Subject: **WATR 2007o – Bunche Park Water Main Replacement Project**
Notice of Change of Conditions

**RE: Notice of Change of Conditions
City of North Miami Beach – Bunche Park Water Main Replacement Project
Project No. 24-016-SG**

We have now quantified the change of conditions to include 6 different changes quantified below.

TYPICAL PAVEMENT RESTORATION

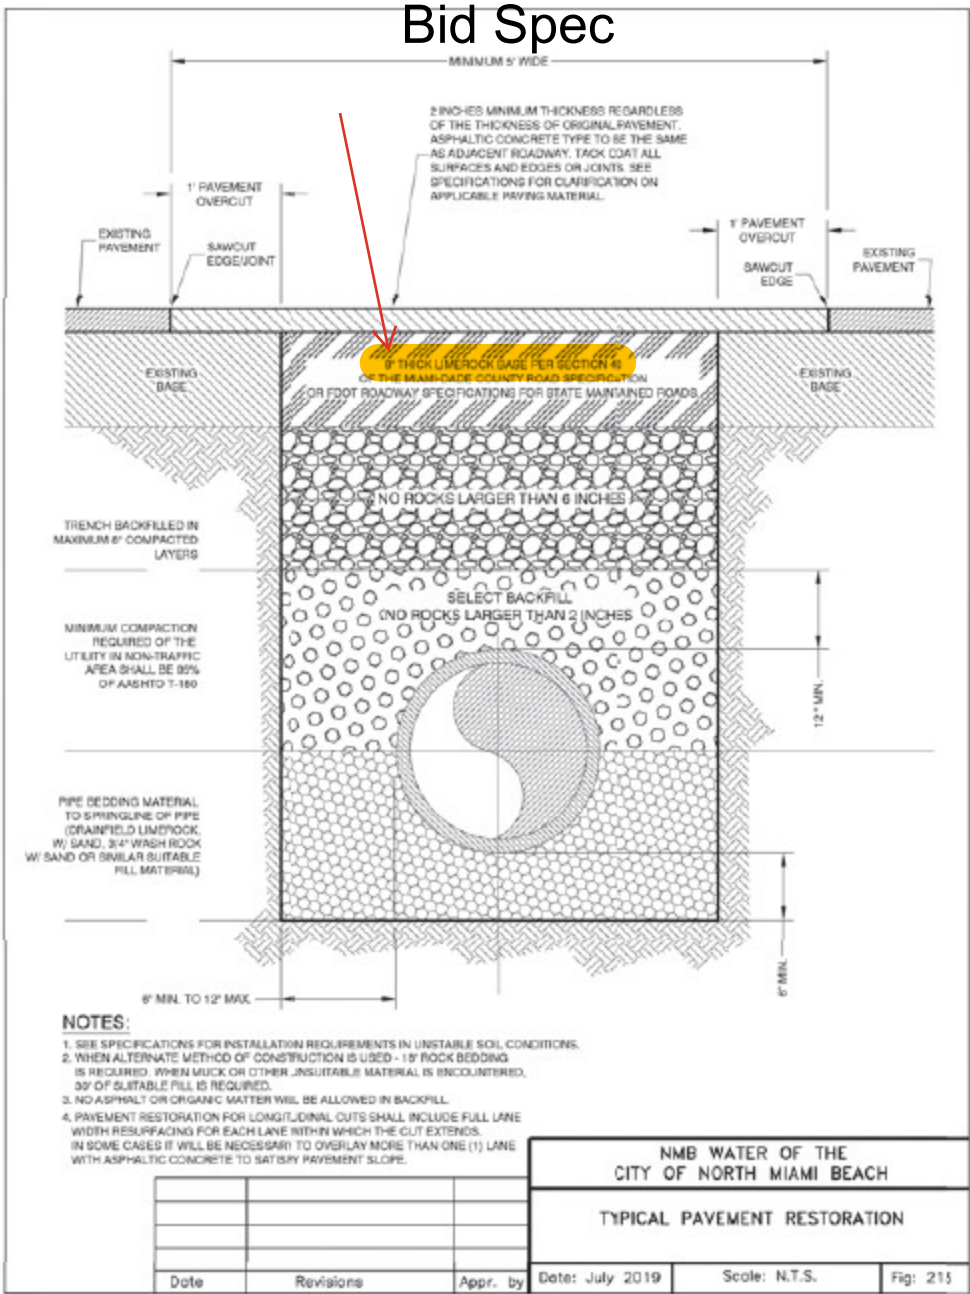
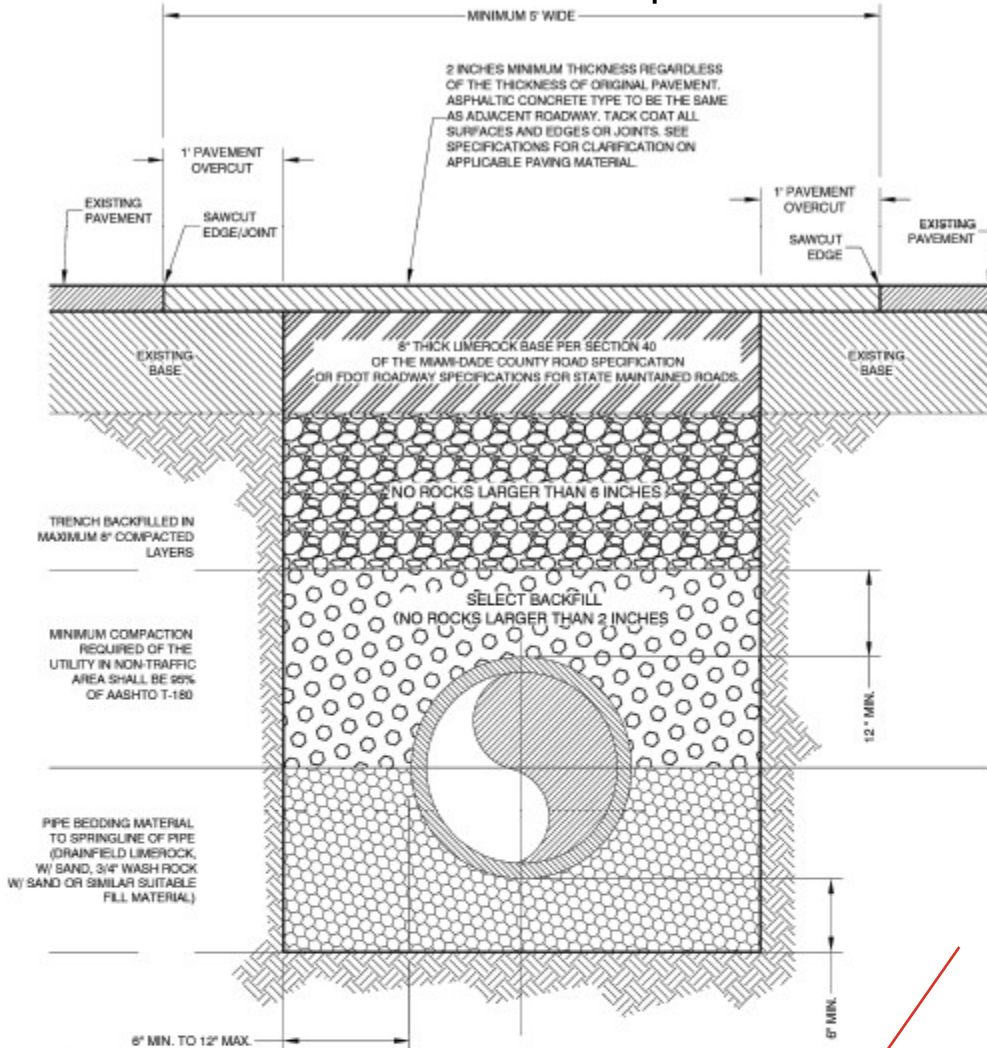
- Change of conditions item #1 includes the additional limerock and labor to go from North Miami Beach spec of 8” thick of limerock to Miami Gardens spec of 12” thick of limerock for a cost of \$25,208.80.
- Change of conditions item #2 includes the additional mill and overlay limits the city of Miami Gardens demanded in order to receive the ROW permit which cost is \$87,880.56.
- Change of conditions item #3 includes the increased densities the city of Miami Gardens requests as part of the ROW permit conditions which is now every 100’ instead of every 300’ which was the bid spec which cost is \$15,000.00
- Change of conditions item #4 includes payment for overtime requests in order to have city of Miami Gardens onsite every Fridays to witness densities since they are closed on Fridays, which cost is estimated at \$10,938.00

AW 01 - Additional Limerock quantities/ Labor

Limerock Calculations

Length (Ft)	Width (Ft)	Depth (In)	CuFt	Compaction Factor (1.75)	Tons	\$/Ton (\$30)
4261	5	8	14203.33333	24855.83333	920.5864198	\$27,617.59
4261	5	12	21305	37283.75	1380.87963	\$41,426.39

Bid Spec

Miami Gardens Spec

FOR MIAMI GARDENS RIGHT OF WAY, 12" LIMEROCK BASE IN (2) 6" LIFTS (EACH LIFT COMPACTED TO 98% OF MAX. DENSITY) WITH 0.5" WIDTH OF LIMEROCK BASE TO BE "TRENCH WIDTH PLUS 1.5 FEET ON EACH SIDE MATCH EXISTING ASPHALT (1.5" MIN.); DENSITY/COMPACTION TESTS WILL BE REQUIRED FOR BACKFILLING LIFTS, SUBGRADE AND LIMEROCK LIFTS.

After careful review, we find the proposed changes and associated costs acceptable, given that these revisions were introduced post-bid and were not reflected in the original bid documents. The approved items and costs are as follows:

DATE: 1/18/2024
 DRAWING NO.: PM-4

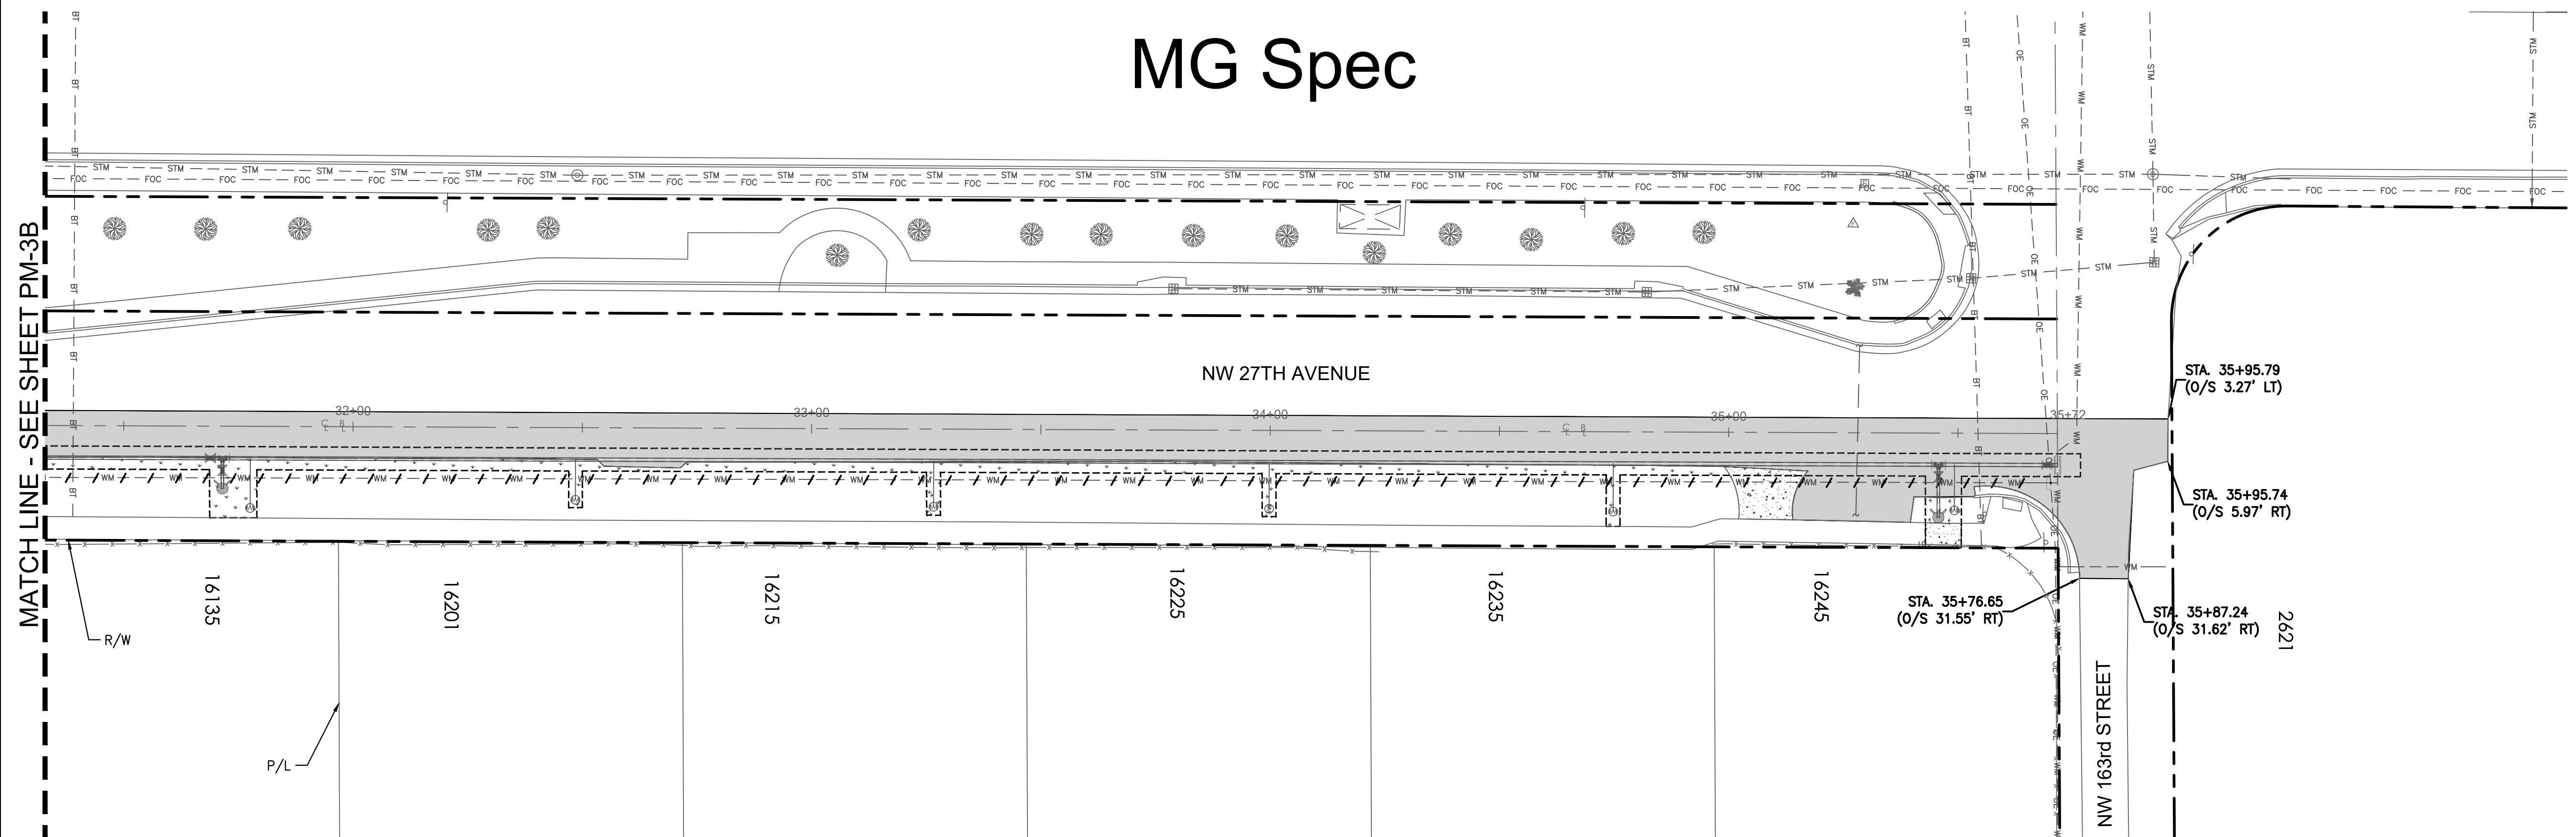
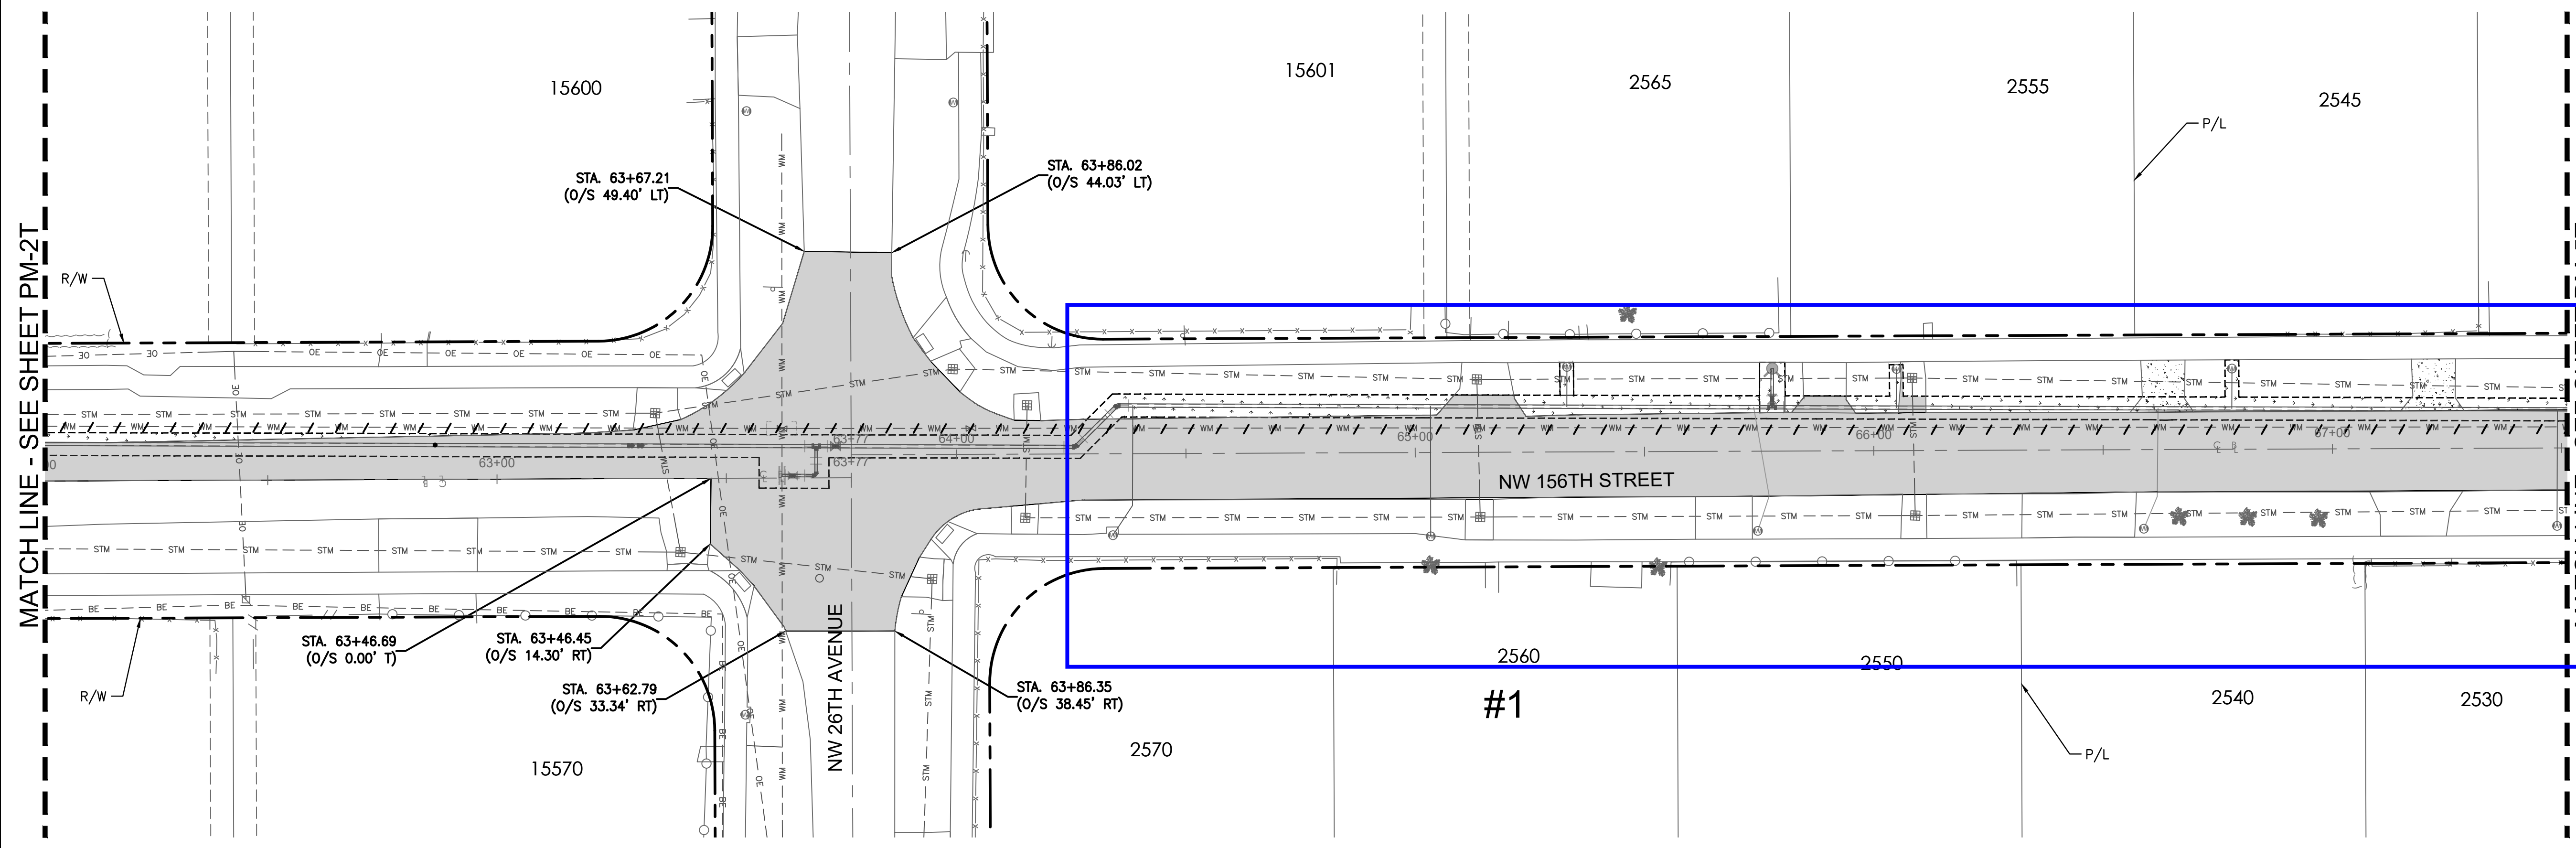
Additional Mill and Overlay Quantities #1									
	Start Station	Stop Station	Page	Total LF	Width	Total SY	Mill \$ (\$3/SY)	Asphalt Overlay (\$14/SY)	Total \$
Bid Spec	64+27	67+61	PM-4 - PM-5	334	10	371.1111111	\$1,113.33	\$5,195.56	\$6,308.89
MG Spec	64+27	69+80	PM-4 - PM-5	553	20	1228.888889	\$3,686.67	\$17,204.44	\$20,891.11
Cost Difference									\$14,582.22
